Planning Application Ref: **AW/328/20/T**

Location: **7 Follett Close, Aldwick, PO21 4XH**

Description of works: **4no. silver birch trees (T95, T96, T97 & T98) - reduce height to approx. 20-25m and Crown lift to 4m**

Figure 2 Positions of final cuts

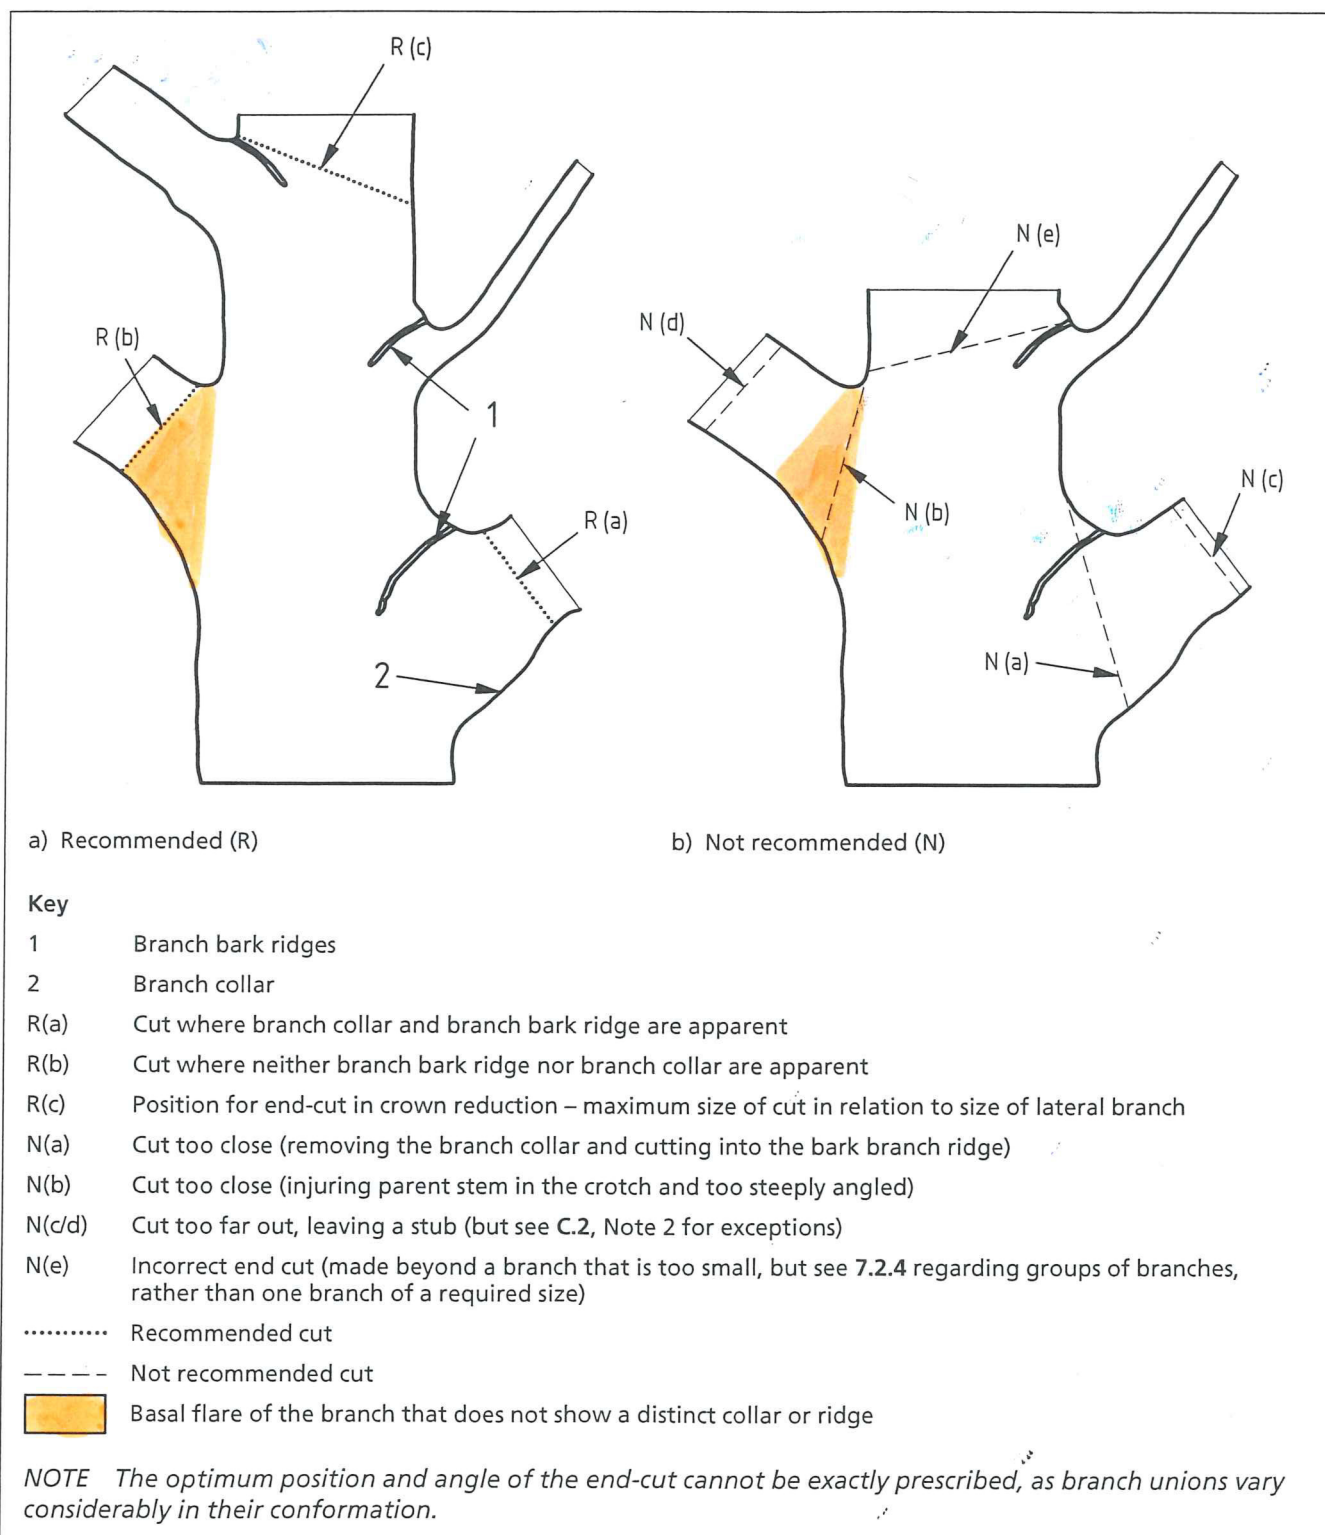
- Part a) Where whole branches are to be removed and final cuts made close to the trunk or branch union they are to be made as shown in Figure 2 of BS3998:2010
- Part b) Where branches are to be shortened back the final cuts are to be made at the correct angle shown in BS3998:2010 and adjacent to a live bud or lateral.
